2006 International Building Code Errata

THIRD PRINTING (Updated December 17, 2007)

FIGURE 1613.5(3)
 MAXIMUM CONSIDERED EARTHQUAKE GROUND MOTION FOR REGION 1 OF 0.2 SEC
 SPECTRAL RESPONSE ACCELERATION (5% OF CRITICAL DAMPING), SITE CLASS B

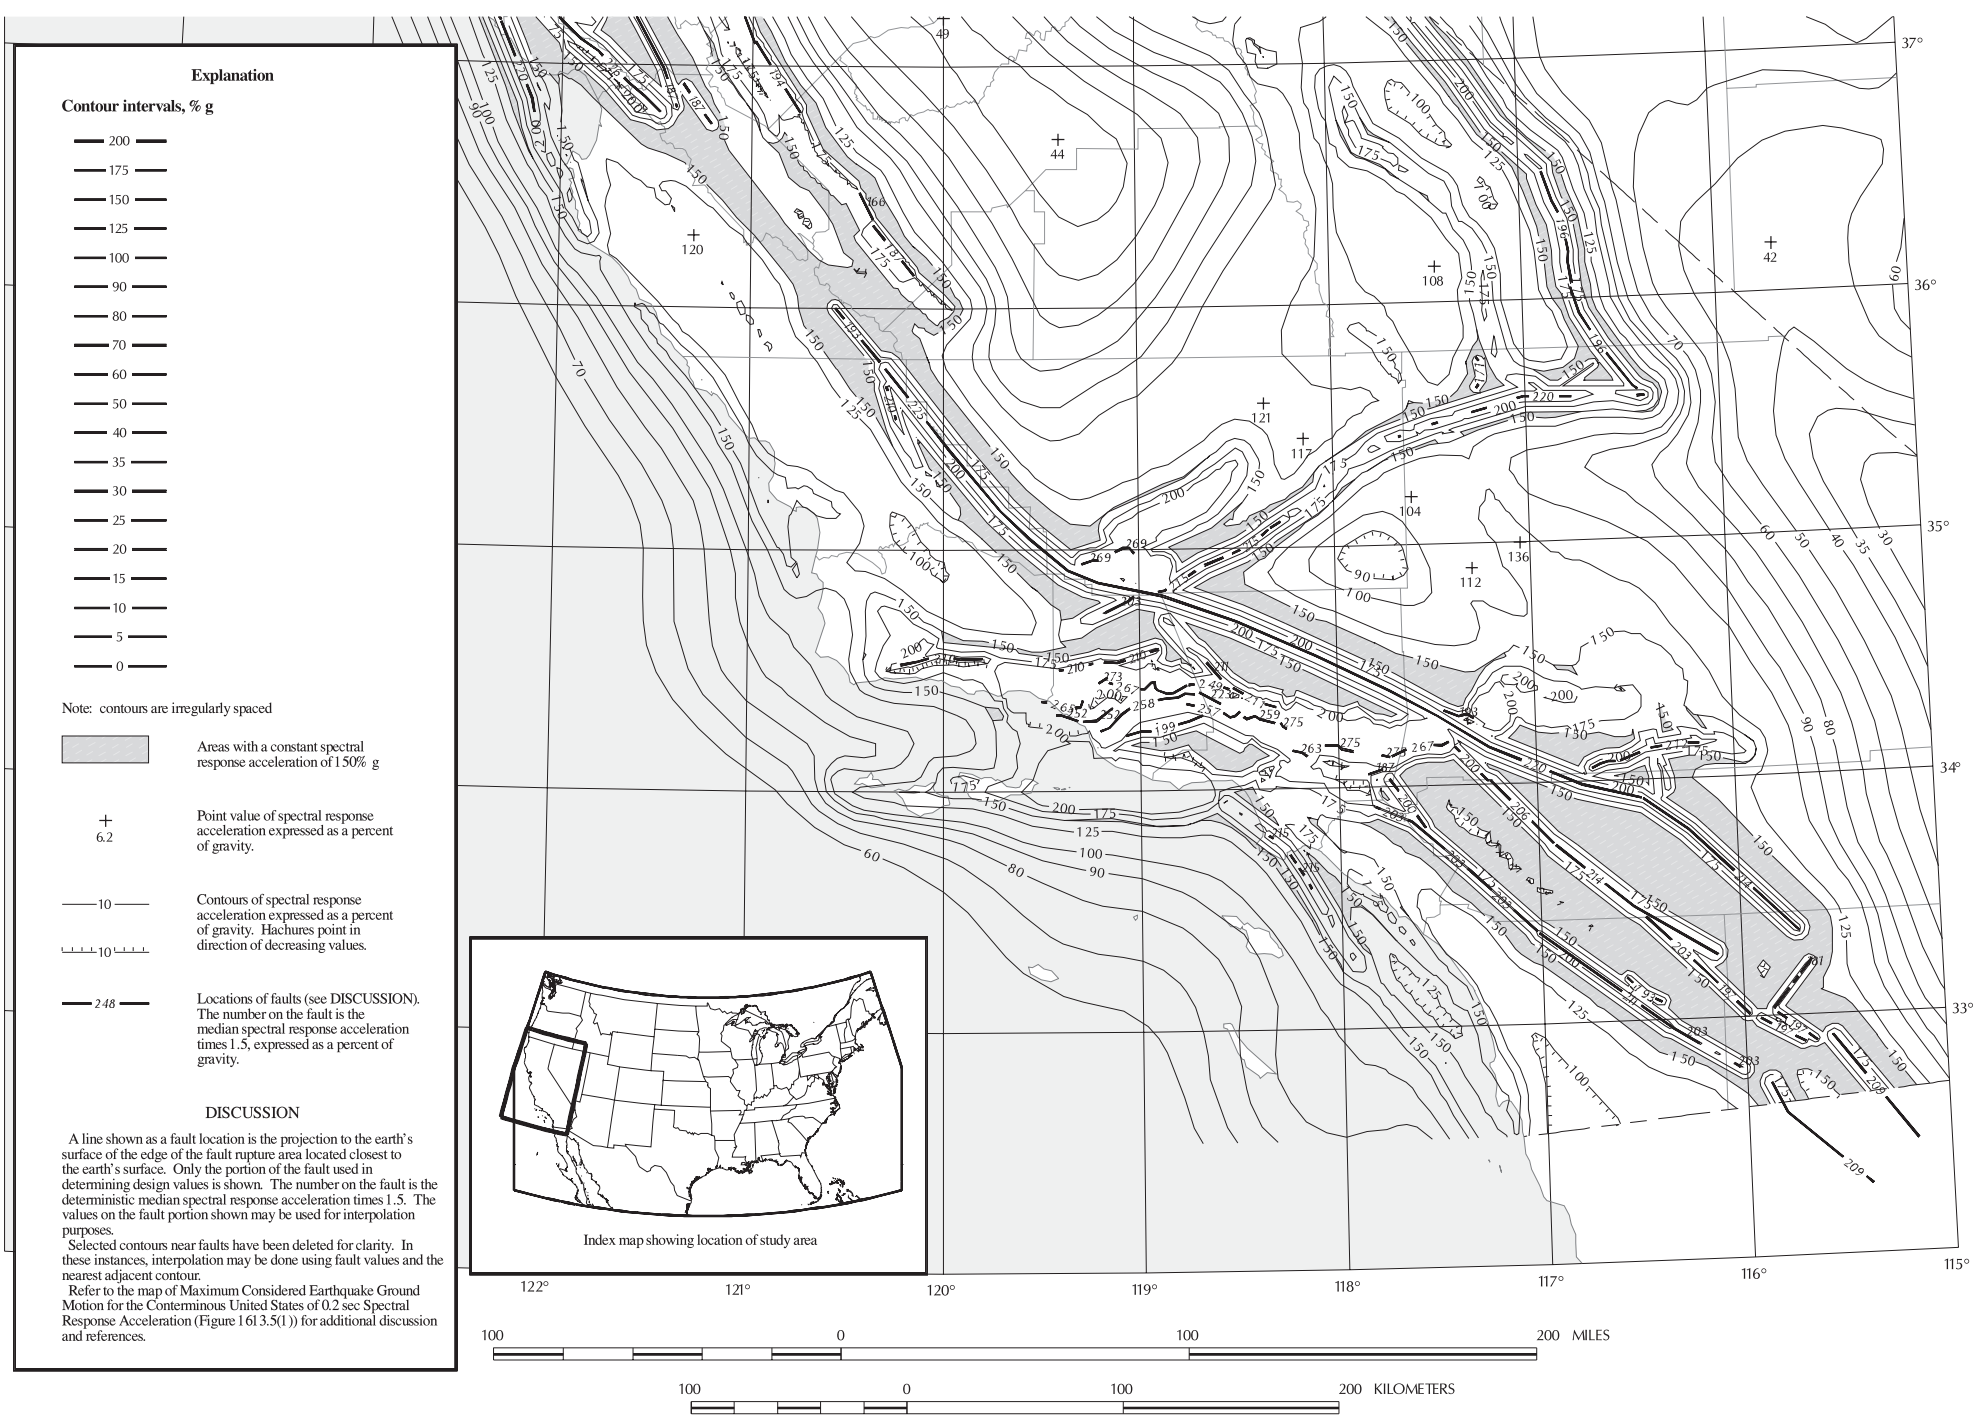
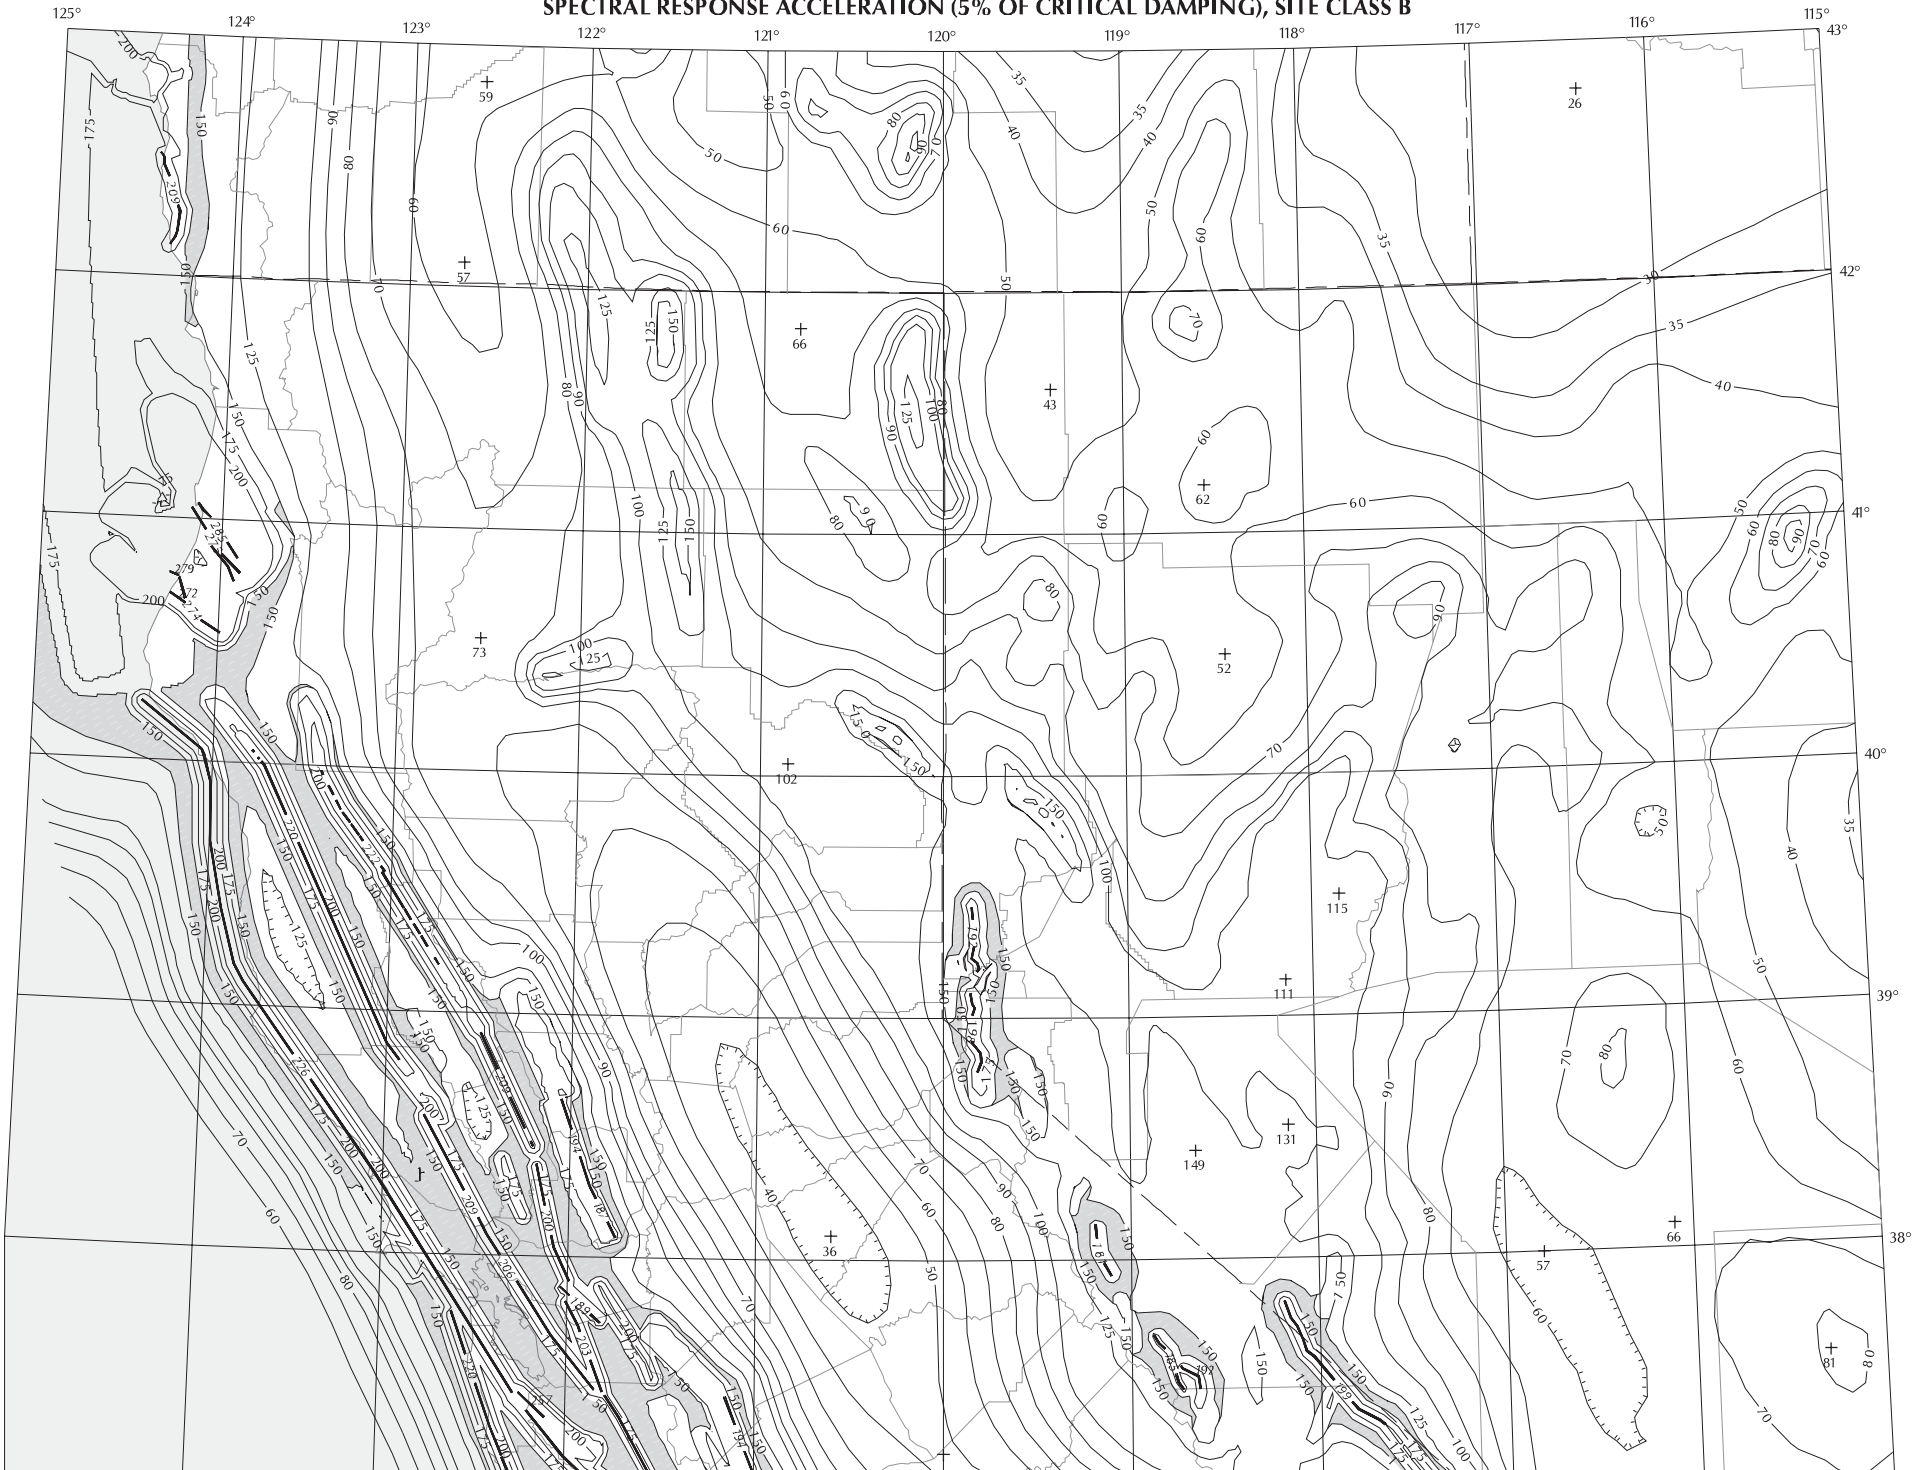
FIGURE 1613.5(3)

MAXIMUM CONSIDERED EARTHQUAKE GROUND MOTION FOR REGION 1 OF 0.2 SEC SPECTRAL RESPONSE ACCELERATION (5% OF CRITICAL DAMPING), SITE CLASS B *(posted 12-17-07)*
